Access Compliance Report

Public Rights-of-Way

(Curb Ramps)

Intersection ID: 13947	Main Street: CHERRY_ST	Cross Street: E_1ST_ST	Location: SW
ADA ID: D3DFD928CB2D	Ramp Type: PerpDiag	Initial Pass/Fail: Fail	Overall Compliance: No
			Severity Score: 33.75

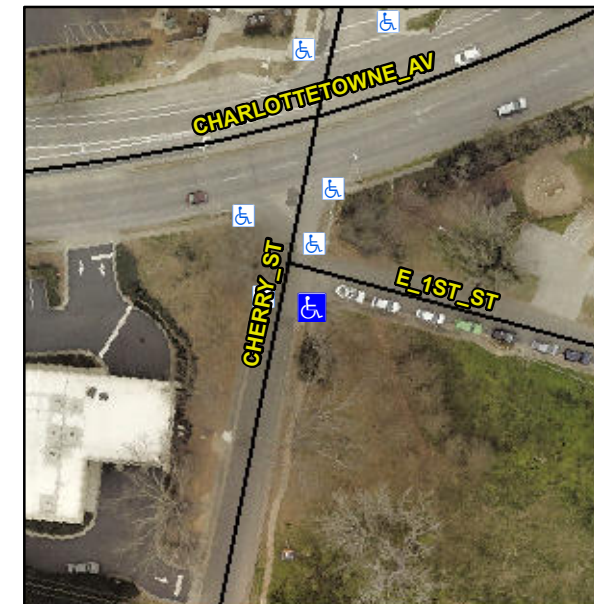
Not Found, R304.5.1, R304.2.2, R304.5.3

Compliance	Description	Data	Compliance	Description	Data
N/A	Ramp Length (in)	61.0	No	Ramp Slope (%)	9.2
No	Ramp Width (in)	37.0	No	Ramp XSlope (%)	5.7
N/A	Flare Type LT	N/A	N/A	Flare Type RT	N/A
N/A	Flare Slope LT (%)	N/A	N/A	Flare Slope RT (%)	N/A
N/A	Flare Traversable LT?	N/A	N/A	Flare Traversable RT?	N/A
N/A	Landing Length (in)	N/A	N/A	DWS Provided?	N/A
N/A	Landing Width (in)	N/A	N/A	DWS Contrast?	N/A
N/A	Landing Slope (%)	N/A	N/A	DWS Length (in)	N/A
N/A	Landing X Slope (%)	N/A	N/A	DWS Full Width?	N/A
N/A	Landing Curb? (Y/N)	N/A	N/A	DWS Offset (in)	N/A
N/A	Shared Landing?	N/A			
N/A	Gutter Ponding?	N/A	N/A	Gutter Slope (%)	N/A
N/A	Gutter Lip Ht (in)	N/A	N/A	Gutter X Slope (%)	N/A
N/A	Painted X Walk1?	No	N/A	Painted X Walk2?	No
	X Walk 1 Direction	To NE		X Walk 2 Direction	To NW
N/A	X Walk 1 Width (in)	N/A	N/A	X Walk 2 Width (in)	N/A
	X Walk 1 Slope (%)	3.2		X Walk 2 Slope (%)	1.3
	X Walk 1 X Slope (%)	2.2		X Walk 2 X Slope (%)	3.0

Remove & Replace Curb Ramp With Two New Directional Ramps or Equivalent.
